Ref RM200488 and RM200489

RE: Further Information Request for Resource Consent Applications – RM200488 – To disturb land and rehabilitate for the purpose of gravel extraction. RM200489 – To erect signage and use an unformed legal road for traffic purposes.

Peach Island Gravel Extraction

#2002 CJ Industries - Peach Island
Mean winter groundwater level, 2015 Lidar DEM

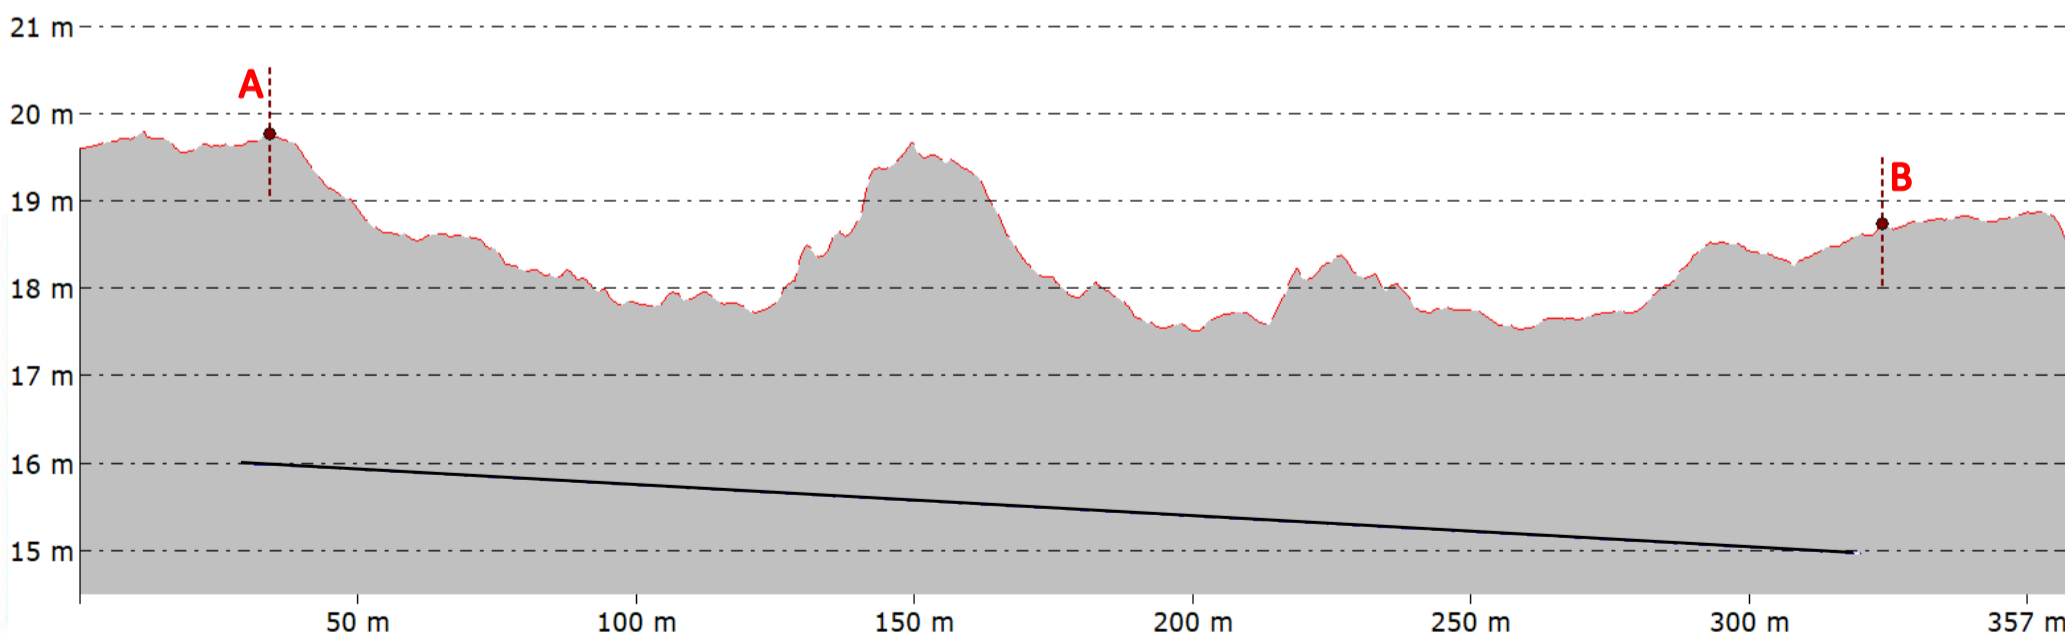
- a. A ground survey which shows contours across the site referenced to a common datum.
- b. A piezometric survey which shows groundwater contours across the site referenced to a common datum and its variation between seasons (high and low).
- c. Defined water table levels across site referenced to a common datum. The water table can vary up to around two metres so please explain how you have determined this level.
- d. The maximum depth of excavation across the site and how this will be monitored and complied with.

Please find attached at Appendix C a plan prepared by Kelly Norris of Mapazzo showing ground levels across the site based on Lidar data. The plan also shows mean winter groundwater level contours across the site, based on the results of piezometric data obtained in 2020. It is understood from our previous discussions that mean winter groundwater levels are sufficient, rather than the full seasonal variation, on the basis that excavations are not proposed below the mean winter groundwater level.

The Mapazzo plan includes a section through the proposed Stage 1 extraction area showing ground surface levels and mean winter groundwater levels. These are both referenced to the NZVD (2016) datum. It is envisaged that conditions of consent will require excavations to be regularly surveyed to ensure that they do not extend below the mean winter groundwater levels that have been established. This information will be recorded and provided to Council at agreed intervals.

LANDSCAPE MITIGATION PLAN

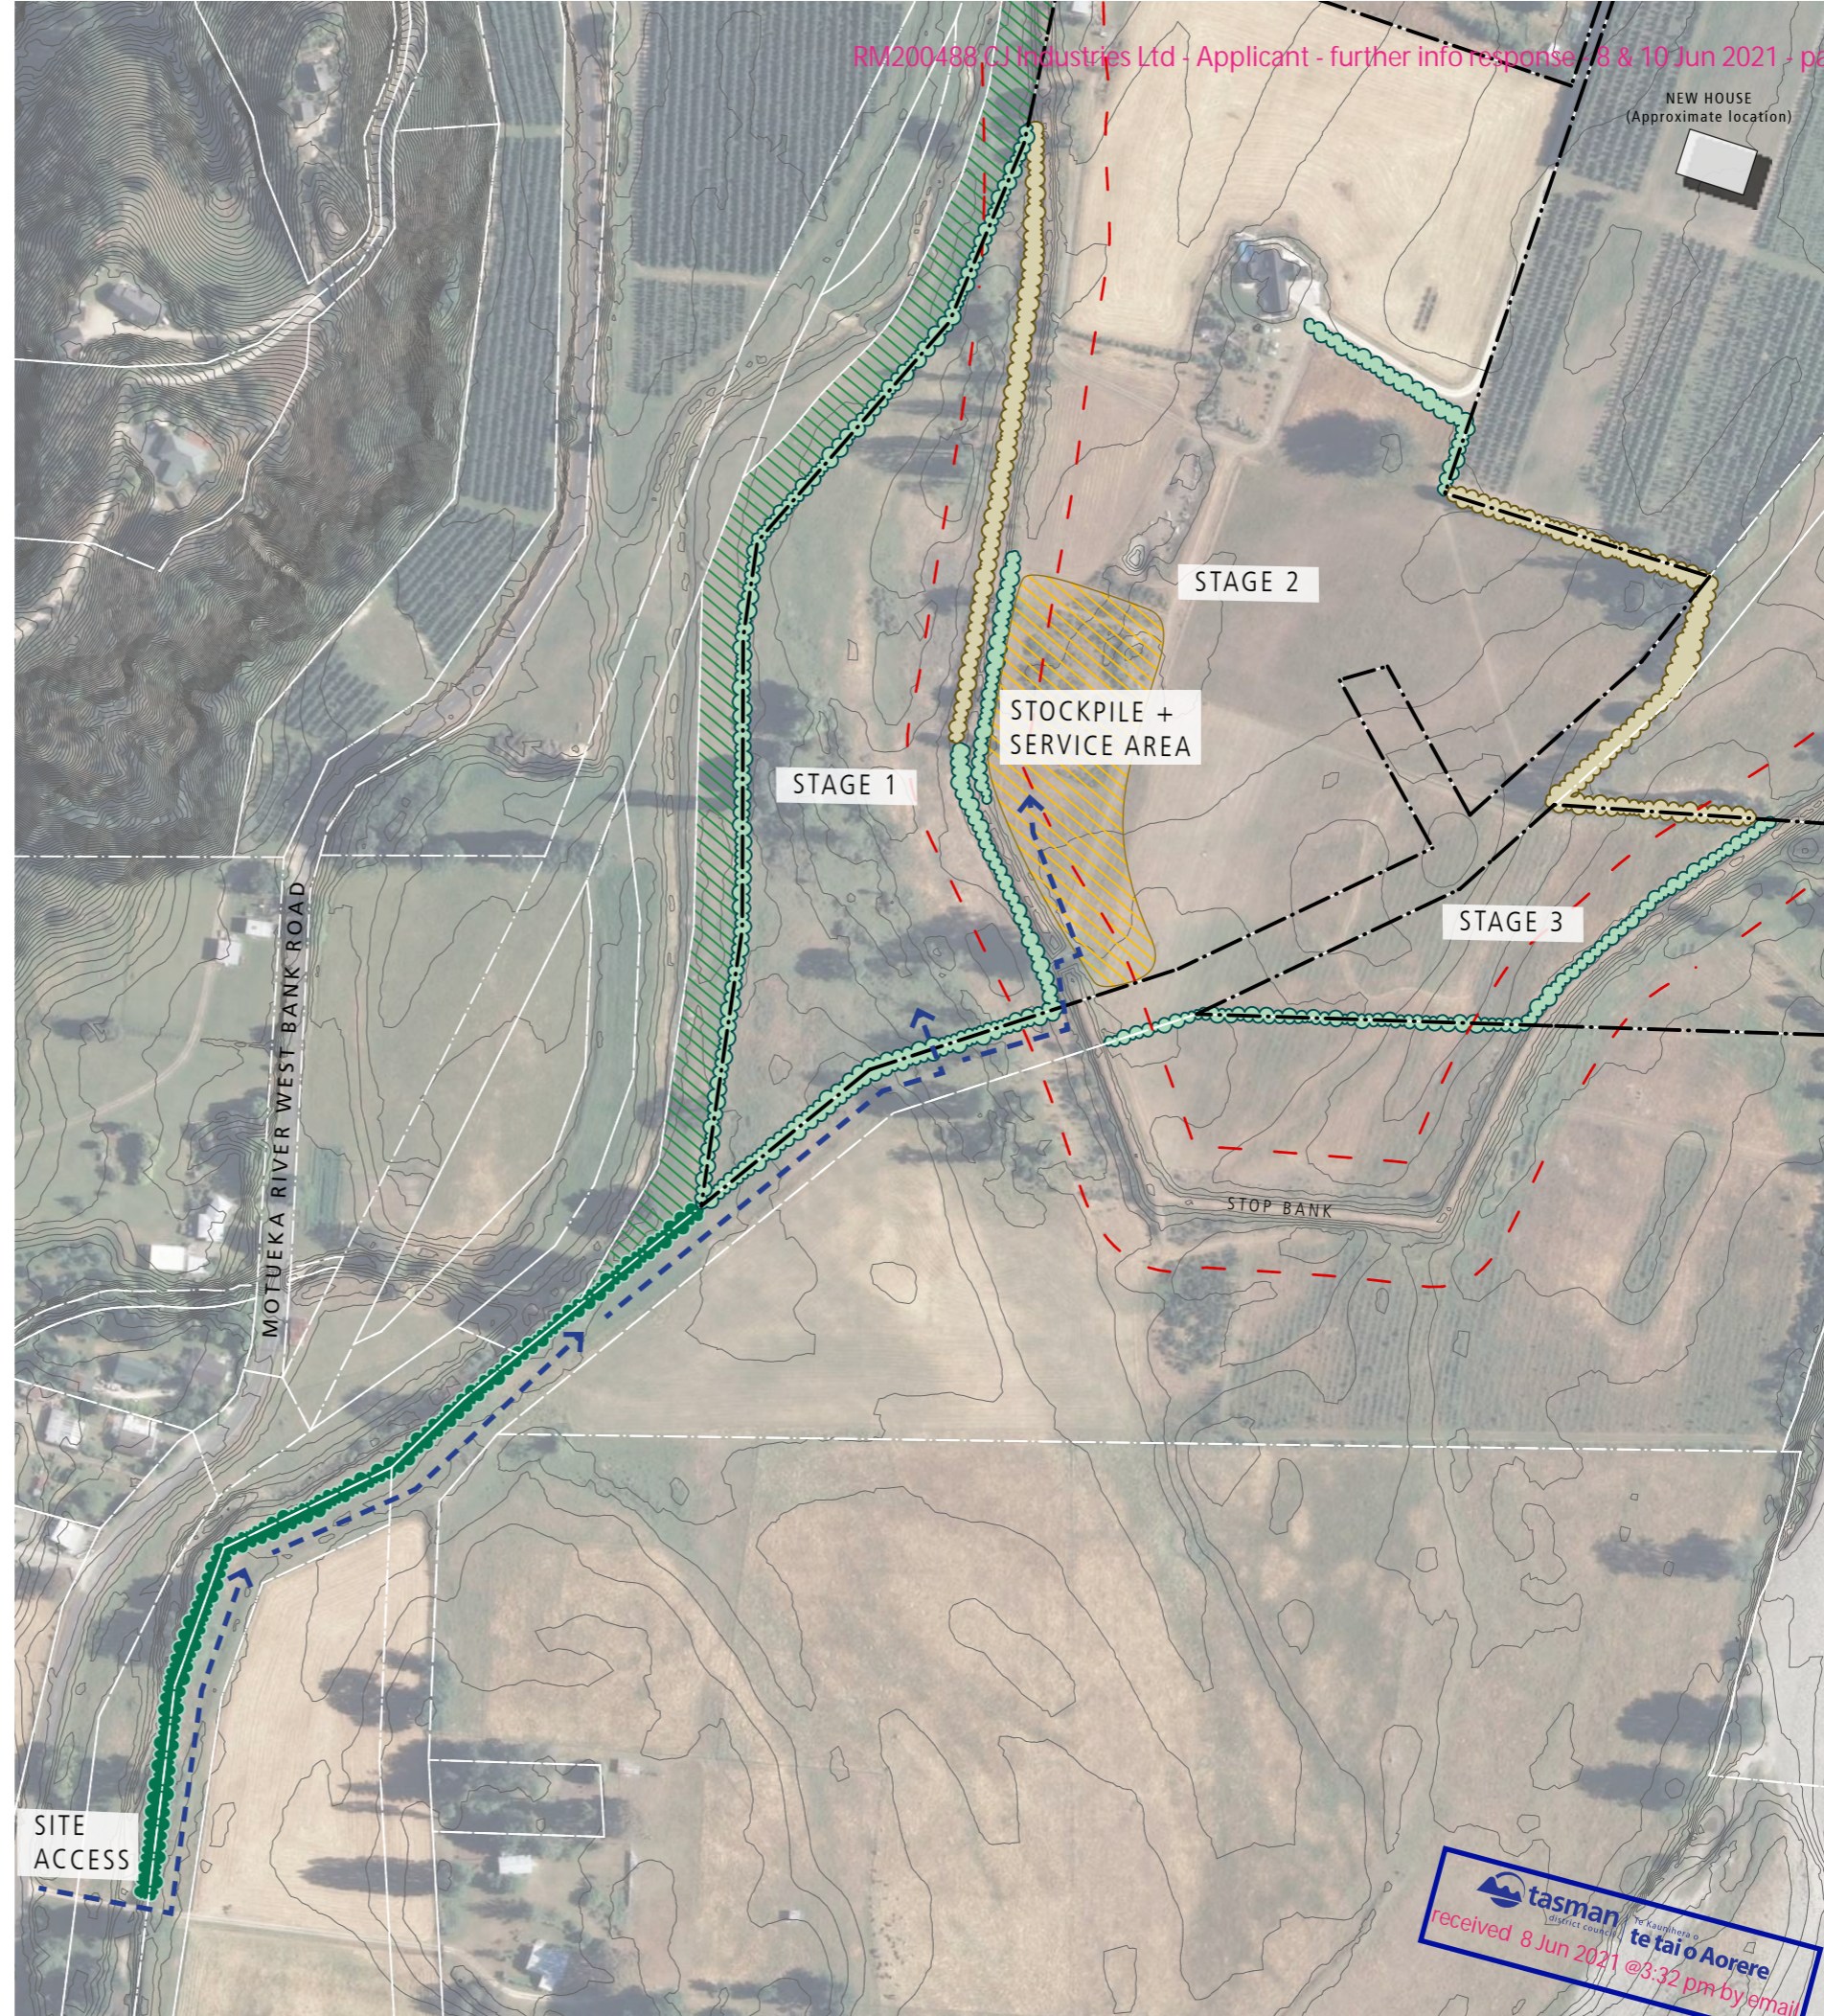
5. Your application states you intend to carry out amenity planting, please provide a planting plan which includes species, timing and management etc.

Canopy have prepared a Landscape Mitigation Plan to address this request. Please find attached at Appendix E.
